ABWR

Upper Drywell SHIELDING.

PLEASE FIND ATTACHED MODIFICATION  
ALONG WITH FIGURE 12.3-74. ALSO A  
FIGURE SHOWING RADIATION FIELD PRIOR  
TO ADDITIONAL SHIELDING IS ATTACHED  
FIGURE A.)9206260036 920601  
PDR ADDCK 05200001  
A PDR

Figure 12.3-74 Upper Drywell Shielding Radiation Dose Rates with Fuel Bundle on Refueling Bellows. (Rads/hr)

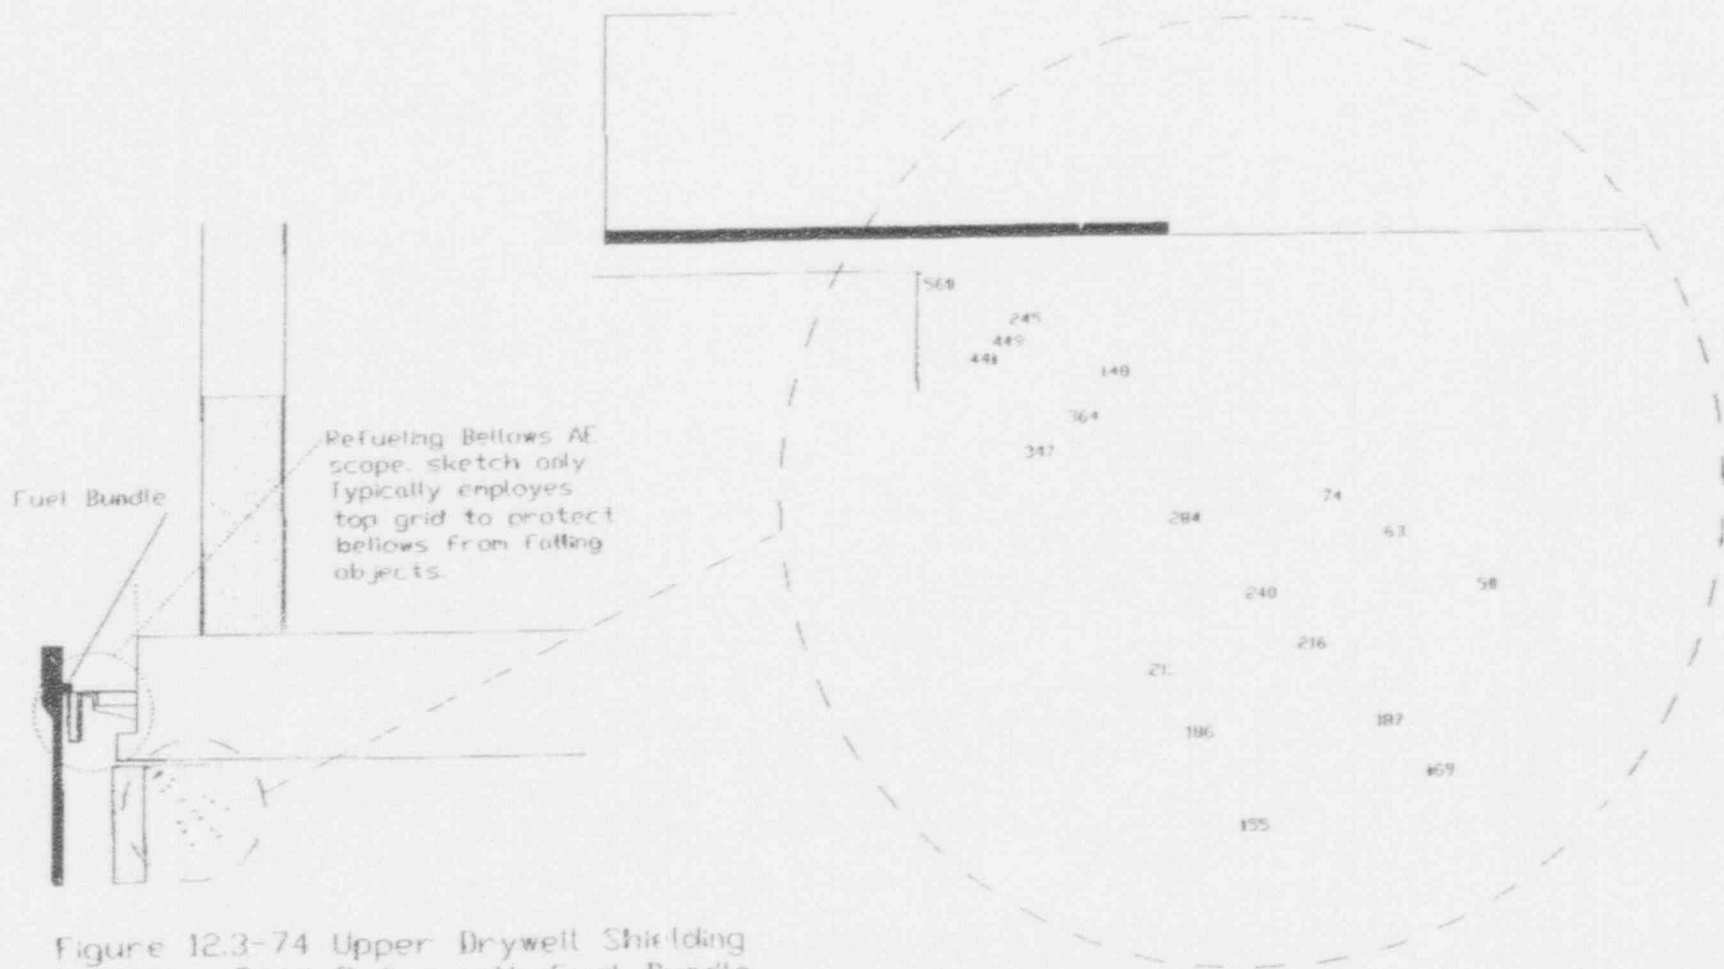
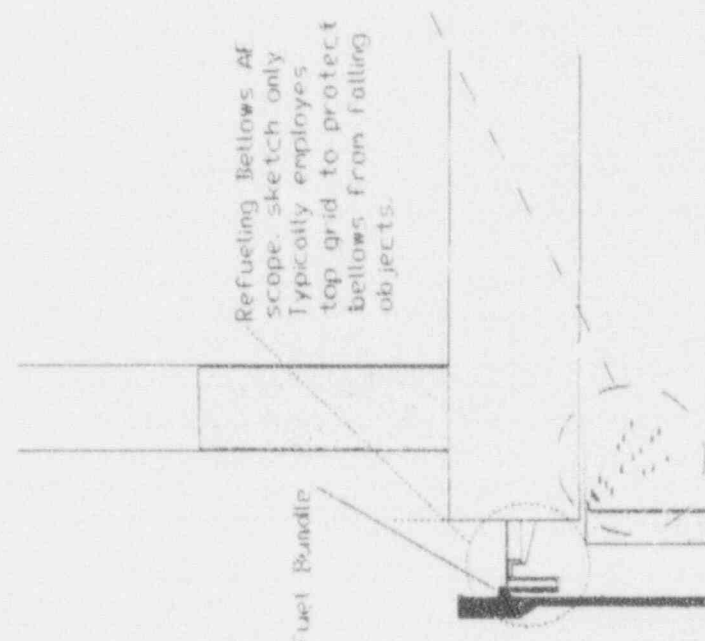
Add paragraph following first paragraph on Page 12.3-12

The upper drywell radiation shield design differs significantly from prior BWR designs in that the upper drywell shield extends to within four inches of the drywell ceiling thereby presenting a collimated angle to the upper drywell for fuel bundles as they are raised from the core to the upper pools. The design is shown in Figure 12.3-74. This design also protects from the remote possibility of a fuel bundle being dropped onto the refuelling bellows in that a lip has been added to the upper drywell ceiling to shield and collimate radiation streaming into the upper drywell from a fuel bundle on the bellows. This lip which extends 1.2 feet toward the vessel from the drywell ceiling wall and is 1.7 feet in height, consists of concrete with the bottom two inches of the lip made of steel with the steel plate extending two feet into the upper drywell. The radiation fields generated by a dropped fuel bundle even are shown in Figure 12.3-74 and though not low are sufficiently low to permit ingress of the area without significant operator exposure. The radiation field as shown in Figure 12.3-74 runs at a maximum 560 R/hr in the far upper corner nearest the bundle, dropping to less than 300 R/hr within 50 cm and below 100 R/hr at 1.5 meters from the corner.
